## **Manufacturing Bulletin**

**Subject: QFN 11mm x11 mm (NO/NOG 148) Tray Conversion**

**Date: 15August 2011**

### **Attachment I**

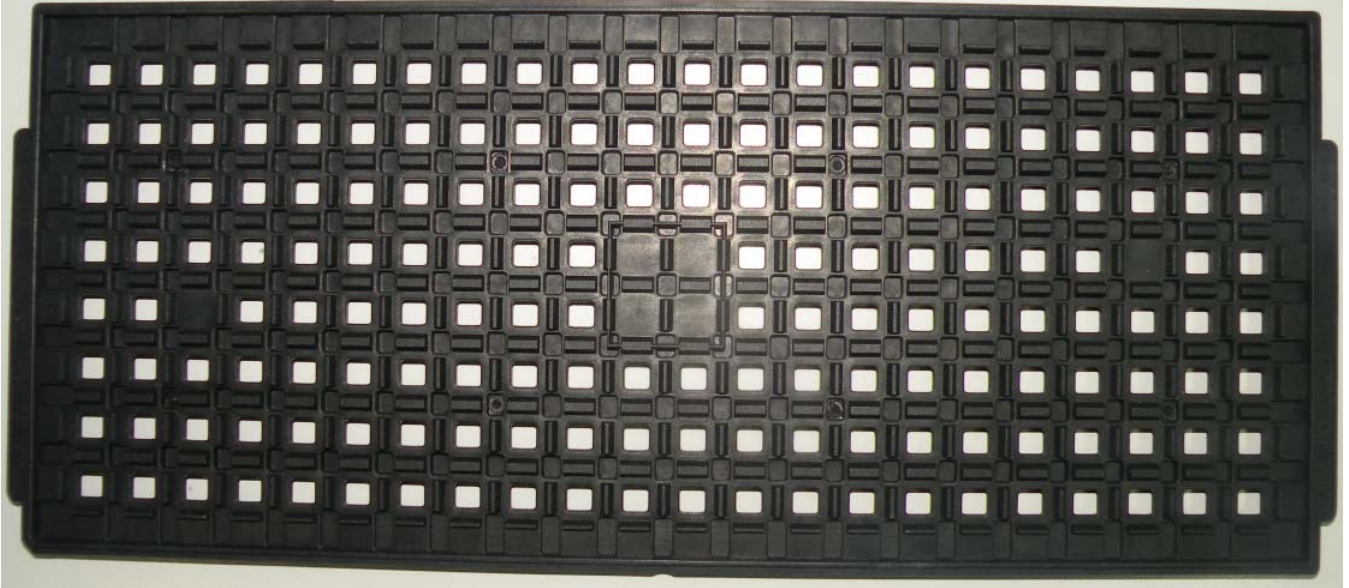
**There are changes in the tray pocket dimensions. However, there are no changes to tray outer dimensions and number of units per tray.**

**Refer to attachment I for new and old tray top view differences.**

<b>Description</b>	<b>Existing Tray</b>	<b>New Tray</b>
Tray Outer Dimension LengthxWidth	135.9 x 322.6 mm	135.9 x 322.6 mm
Tray Pocket Dimension Length x Width x Depth	11.23 x 11.23 x 1.40 mm	11.20 x 11.20 x 1.30 mm

### **Attachment II**

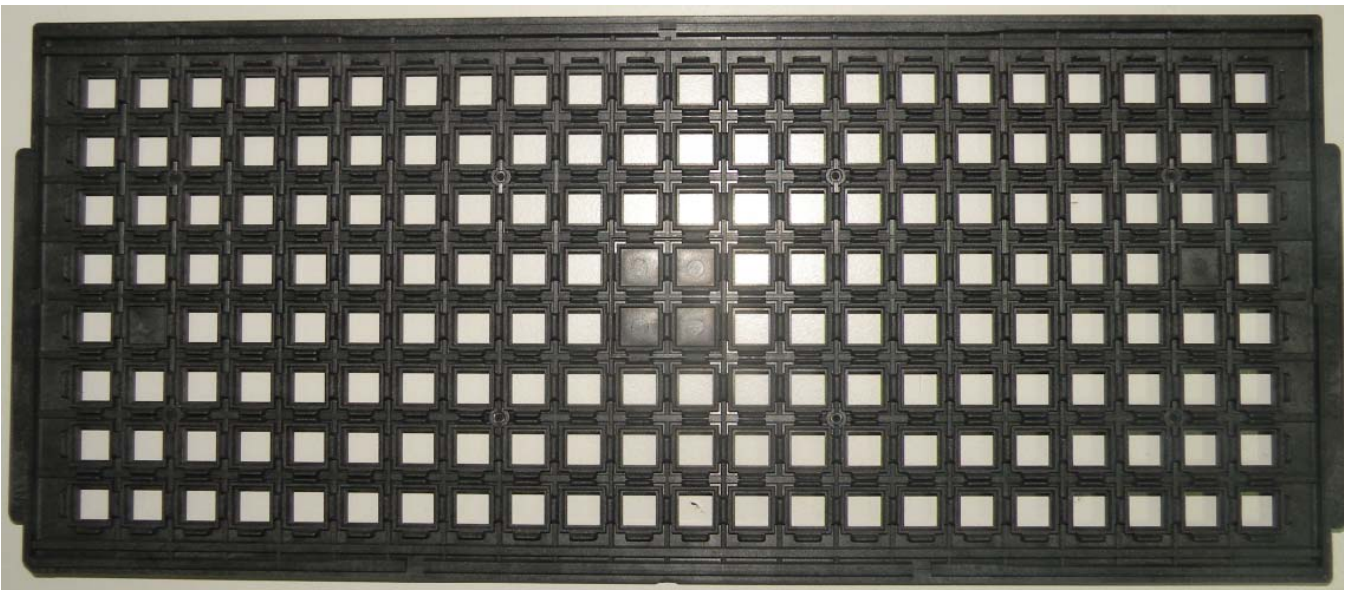
<b>Description</b>	<b>Reason for Change</b>
Pocket dimension	To ease the detection of double units inside tray pocket. (refer to attachment II(a))
Bottom tray pocket with 4 humps	To prevent unit sticky problem due to ESD static. (refer to attachment II(b) )

**(a) New Tray ( has gap if double units per pocket)**

**(b) New Tray (Bottom tray pocket with 4 humps )**
